**METROPOLITAN DEVELOPMENT COMMISSION
HEARING EXAMINER**

Case Number: 2025-CPL-805/ 2025-CVR-805
Property Address: 7515 Camby Road (Approximate Address)
Location: Decatur Township, Council District #21
Petitioner: Abigail Wojciechowski, by David Gilman
Current Zoning: D-3
Approval of a Subdivision Plat to be known as Speer's Camby Retreat, dividing 6.686 acres into three lots.
Request: Variance of Development Standards of the Consolidated Zoning and Subdivision Ordinance to provide for a 45-foot lot width for proposed Lot Two (minimum 70-foot lot with required), and to provide for on-site septic systems for each lot (public sewer facility required).
Current Land Use: Residential
Staff Recommendations: Approval
Staff Reviewer: Desire Irakoze, Principal Planner II

**SECONDARY PLAT OF:
SPEER'S CAMBY RETREAT
A SUBDIVISION OF PART OF THE NE 1/4, SEC. 15, T14N, R2E
INDIANAPOLIS, CENTER TOWNSHIP, MARION COUNTY, INDIANA**

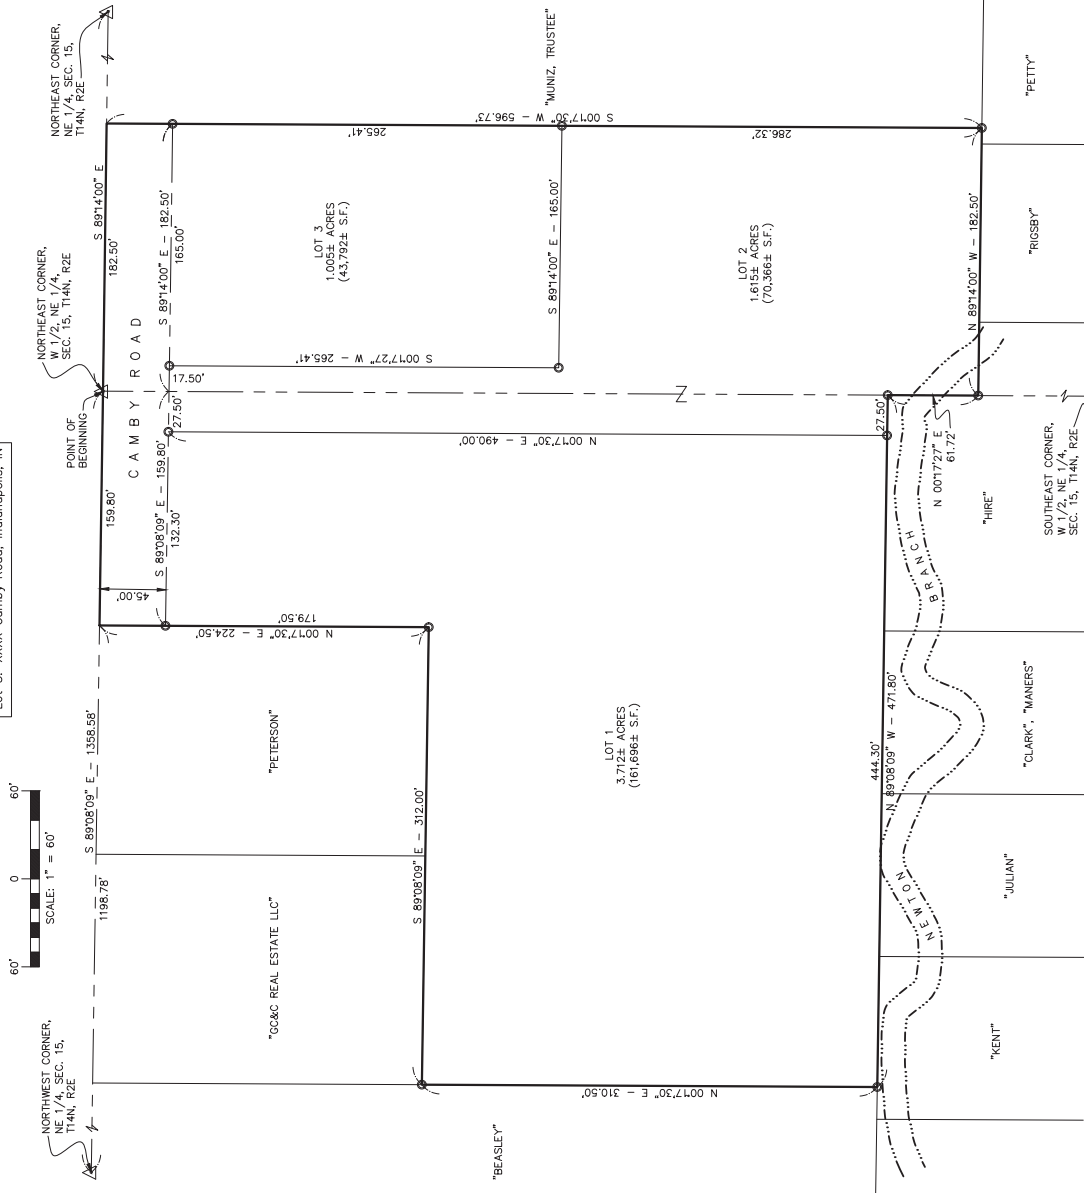
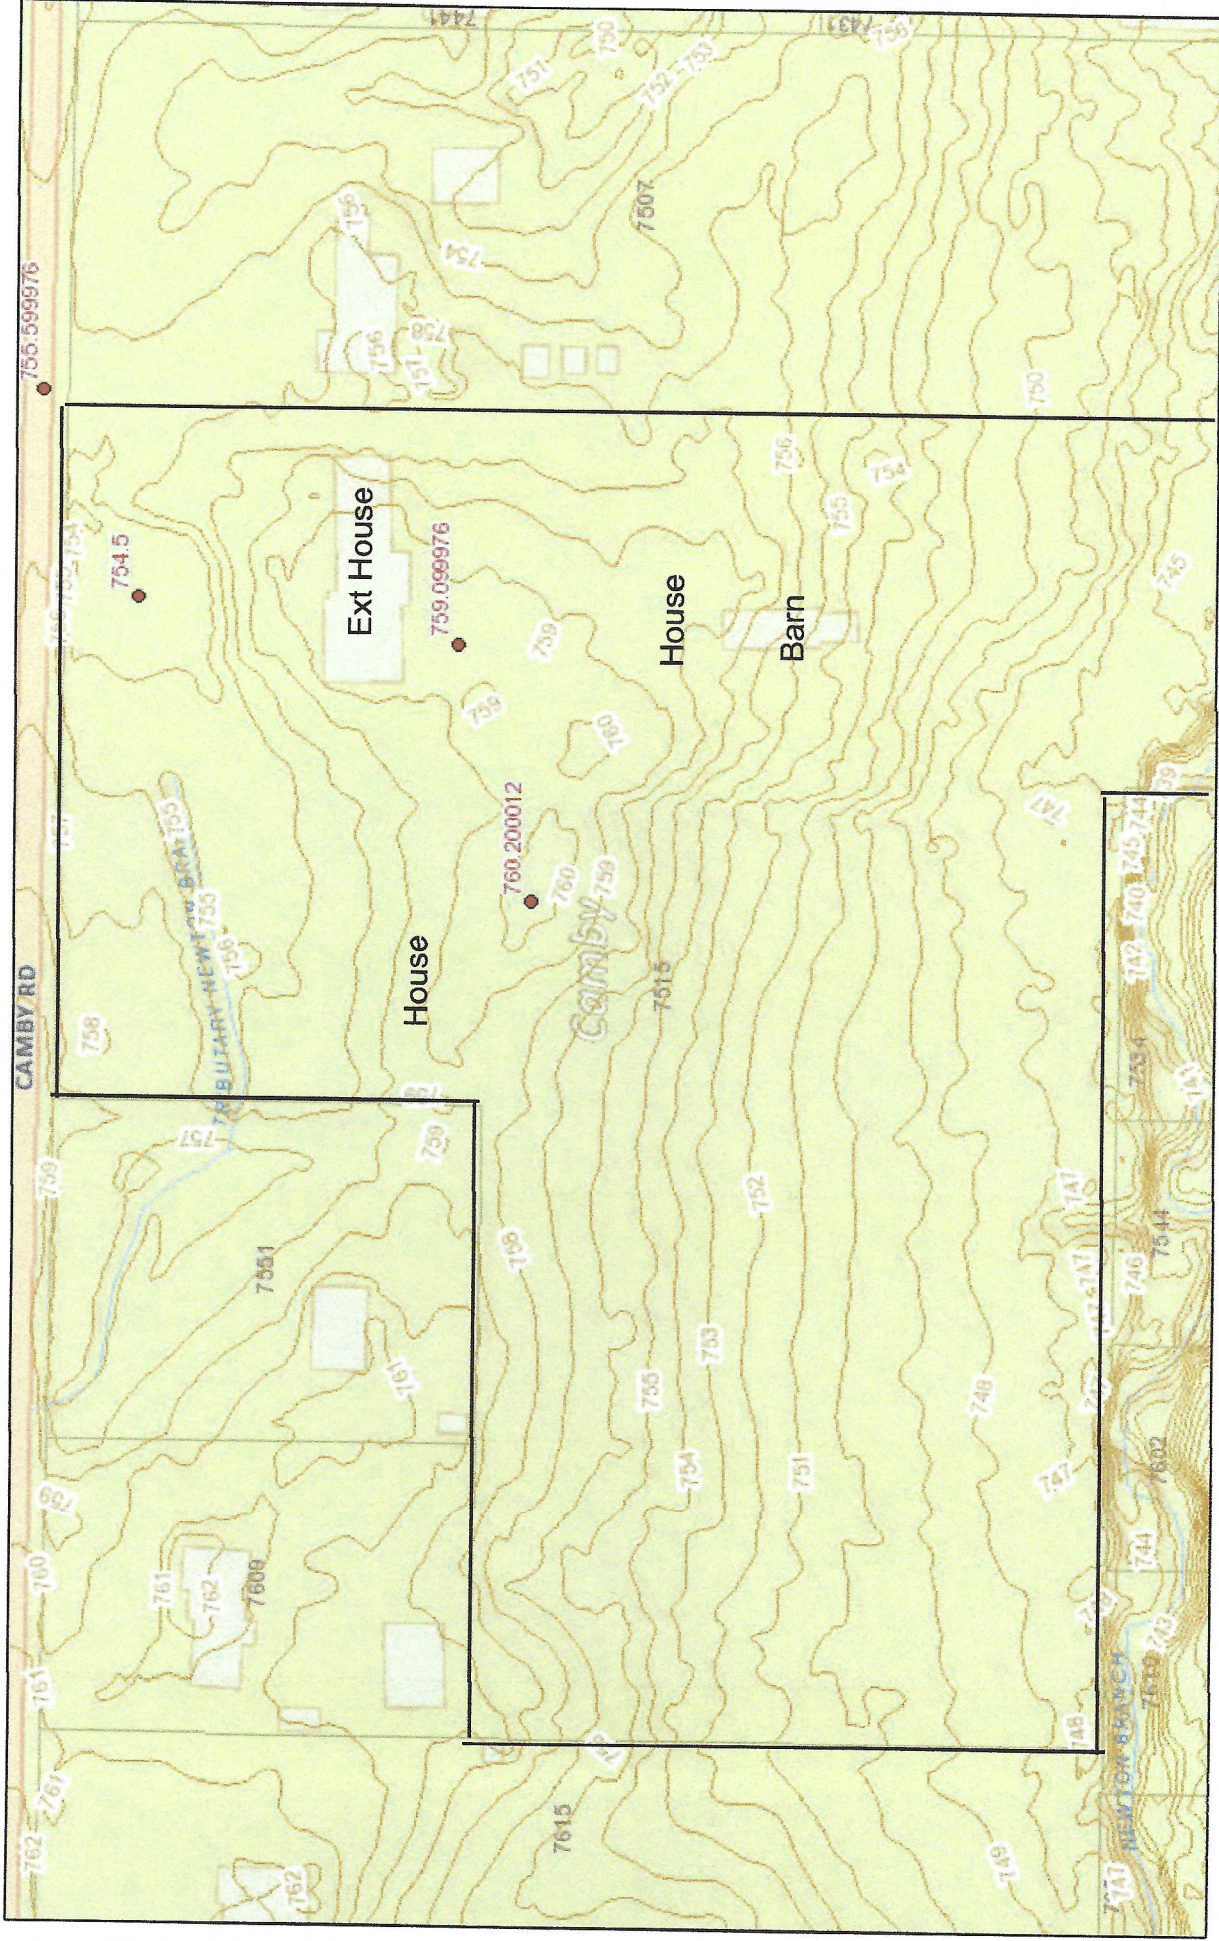
Request #1 : To provide for a 45-foot lot width for proposed Lot Two (minimum 70-foot lot with required)

The property will have an average lot width that exceeds the 70 ft. lot width requirement. Lot width is measured at the building setback line. If we measure the lot with at the proposed building line for lot 2 it would have a lot width of 210 ft.

Request #2 : To provide for on-site septic systems for each lot (public sewer facility required).

The proposed lot sizes are comparable to the D-S districts, which allow for the exemption of the public water and sewer connections. The applicant has agreed that to the condition that when connection to the public line across Camby Road because available to lot 1, all three lots with connect.

<p><i>741.306 – Sidewalks:</i></p> <ul style="list-style-type: none"> • <i>Sidewalks shall be provided along all internal and external streets.</i> 	<p>Not Satisfied</p>

<p>741.316 – <i>Street Lighting:</i></p> <ul style="list-style-type: none"> • <i>All subdivisions must be designed and constructed in accordance with the Street Lighting requirements of Section 744-600 (Street and Exterior Lighting).</i> 	<p>Street lighting not submitted</p>

Staff **recommends approval** of the plat and variance request subject to the following commitment.

1. All lots will be required to connect to the city sewer, when the sewer lines reach the closest lot.

14. That all standards related to 741.305 – Numbering and naming be met prior to recording the final plat.
15. That an amended plat with sidewalks compliant with Section 741-306 of the Consolidated Zoning and Subdivision Ordinance be submitted prior to recording the final plat.

16. That all standards related to 741.310 – Common Areas, Open Space and Public Sites (Compact Context Area) be subject to the waiver request.
17. That a street lighting plat compliant with Section 741-316 of the Consolidated Zoning and Subdivision Ordinance be submitted prior to recording the final plat.
